ITEM NUMBER	10.5
SUBJECT	Planning Proposal for land at 197-207 Church Street, Parramatta
REFERENCE	RZ/4/2015 - D03993596
REPORT OF	Project Officer - Land Use Planning
LANDOWNER	Holdmark Properties Pty Ltd
APPLICANT	Don Fox Planning Consultancy

To seek Council's endorsement to forward a Planning Proposal for the land at 197-207 Church Street, Parramatta to the Department of Planning and Environment for Gateway determination; and to seek endorsement to proceed with formal negotiations to prepare a Voluntary Planning Agreement between Council and the landowner in relation to this Planning Proposal.

Figure 2 – Three Preliminary Concept Proposals on Macquarie Street

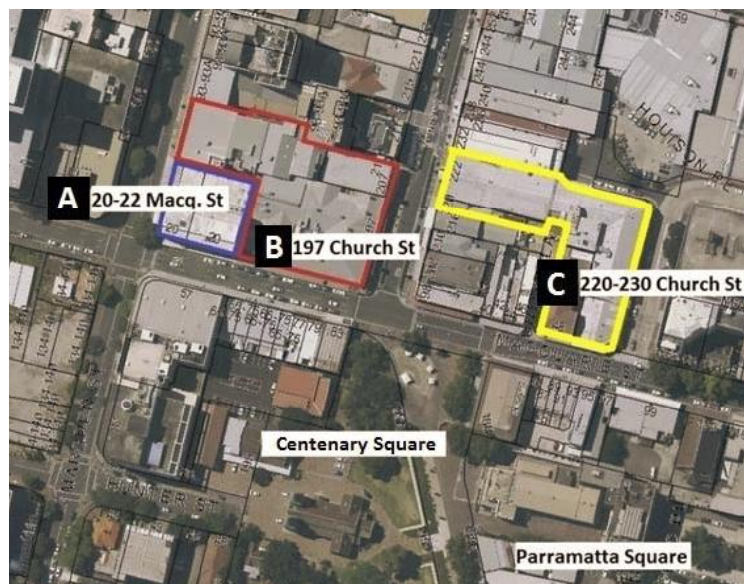
9. The three preliminary concept proposals presented development schemes that sought significant departure from Council's current City Centre height and FSR controls. Common to all three proposals was the intention to increase the level of permitted density on the sites to develop mixed use towers (largely residential). This would produce taller buildings in close proximity to Centenary Square and Parramatta Square; two key public domain areas within the city centre area north of the railway line and south of the river foreshore.

10. The above sites' proximity to Centenary Square and Parramatta Square warranted careful consideration at this early stage of the planning process in order to determine the potential impact on Council's key public domain areas arising from these proposals. This is to ensure the public domain is adequately protected and receives sufficient solar access to deliver a high level of amenity to the space for the community.

Figure 9 – Solar Access Protection in Parramatta Square

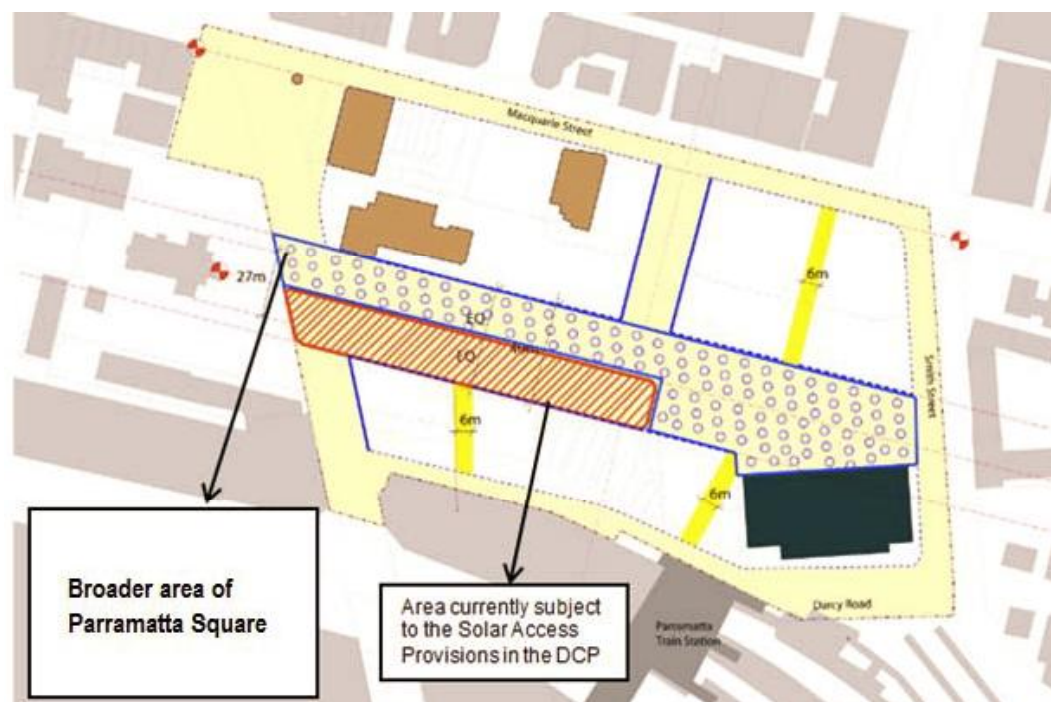
54. At the 23 November 2015 Council Meeting, Council resolved to endorse an amendment to the PDCP 2011 that requires development to 'minimise' the degree of overshadowing. A control was introduced so that buildings must be designed so as to ensure that no point of the area hatched in red in **Figure 9** is in shadow for a period greater than 45 minutes between 12pm-2pm mid-winter.

55. The indicative building envelope and the positioning of the tower to result from the applicant's proposed FSR of 16.5:1 and height control of 250m (or no height control) does not comply with this control. Any future development to result from the proposed planning controls would overshadow one point in the designated area (area hatched in red in **Figure 9**) of Parramatta Square for a time greater than 45 minutes between midwinter 12pm-2pm. Council's 3D Model determined that the proposed development scheme at 16.5:1 would overshadow one point in the designated area for approximately 65 minutes.

56. Council Officers recommend an FSR of 10:1 for the subject site. This is to maintain consistency with the recommendations of the Parramatta CBD Planning Strategy. Officers request the applicant carry out the necessary testing and modelling to determine what FSR and built form can result on the subject site when complying with the solar access provisions resolved by Council that require no point of the protected solar access area of the square to be overshadowed for more than 45 minutes.
